UNITED STATES PATENT AND TRADEMARK OFFICE

Office Action Summary

10/820,186

DETAILED ACTION

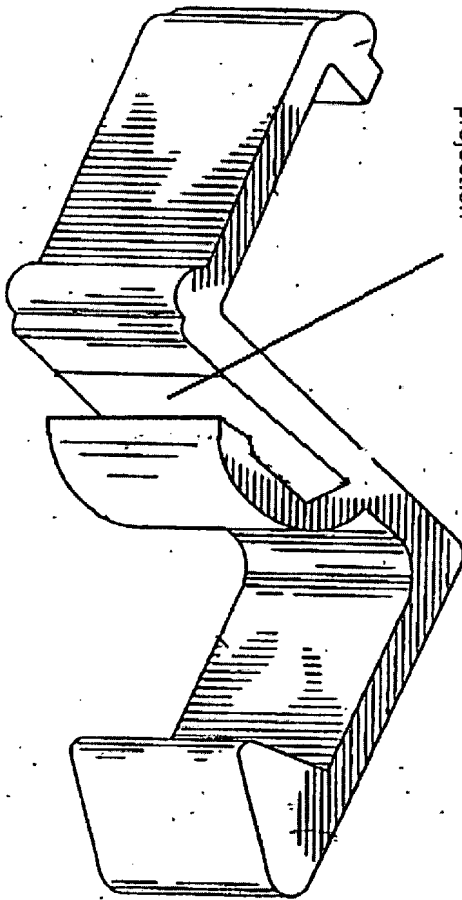
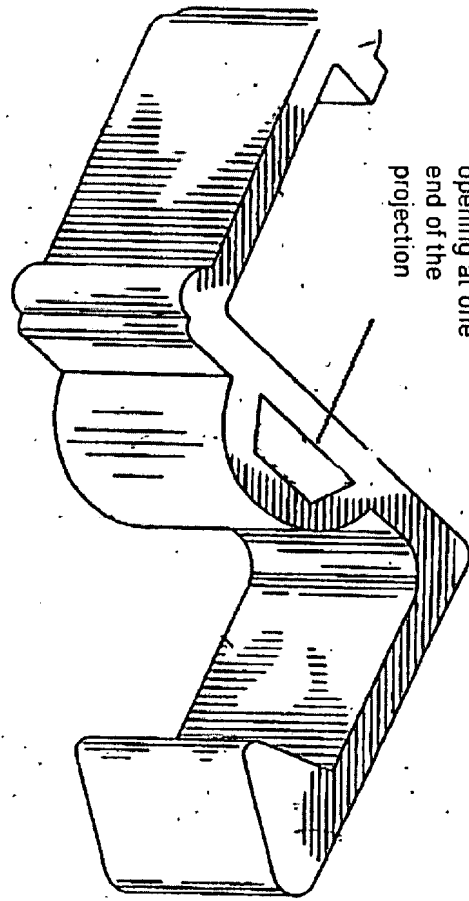
The drawing objection has been withdrawn in view of the explanation given by the applicant, in which the opening referring to in claim 9 is an opening at either side of the cushioning device (for example, Figure 2, where 124 is pointing, and not that the cushioning device is open at one end (see attachment #1).

→ incorrect interpretation

opening at one
end of the
projection

→ correct interpretation

opening at one
end of the
projection

Attachment #2

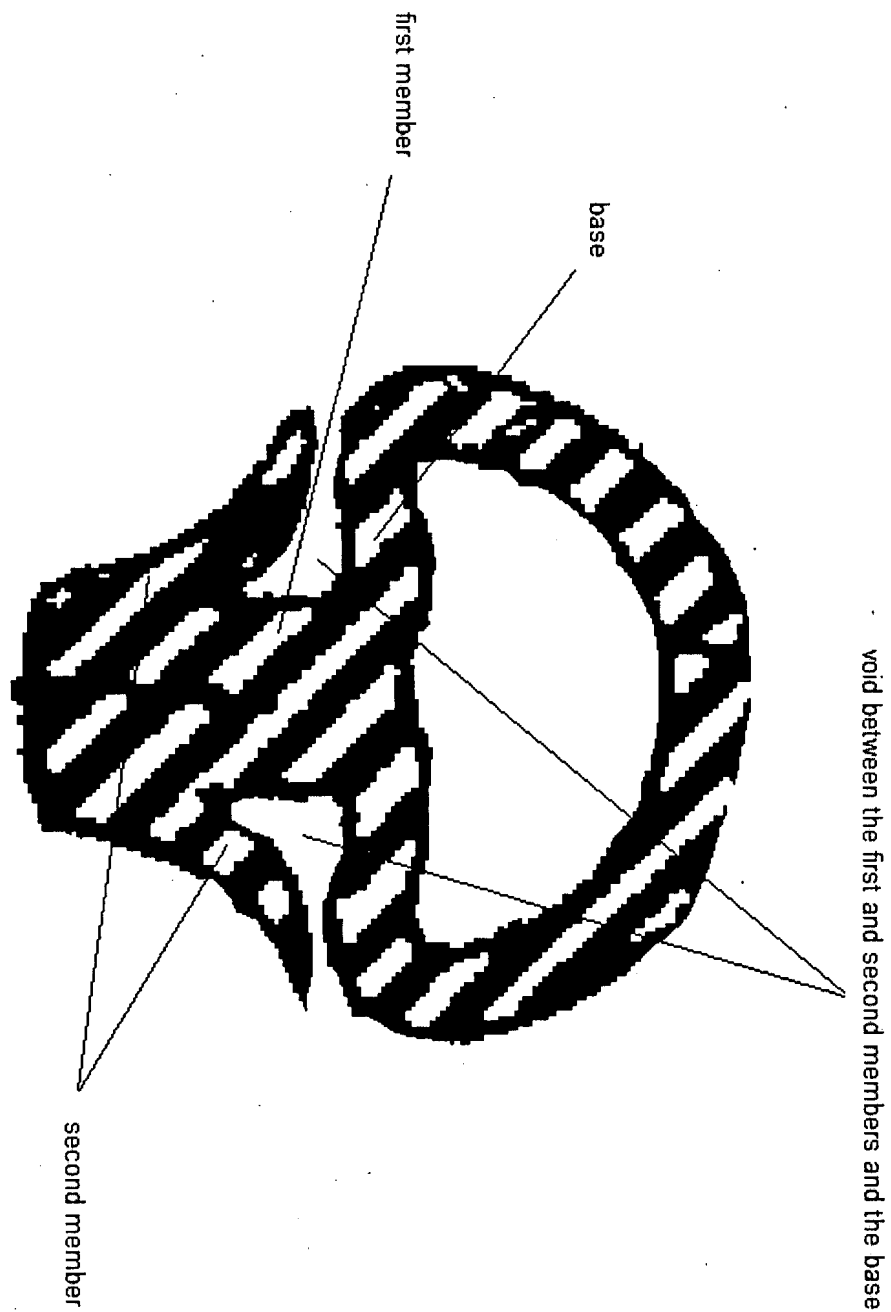
The applicant further argues that neither Tinnerman nor Schanz discloses a first member connected to the base member and a second member connected to the first member, as cited in claim 1 (Page 7 Line 12). The applicant further argues that the prior art fails to show a structure as shown in Figure 5.

As seen in attachment #2, Schanz clearly illustrates this limitation. The applicant needs to clearly claim the invention illustrated in figure 5 so as to overcome this rejection. Therefore, the rejection is maintained.
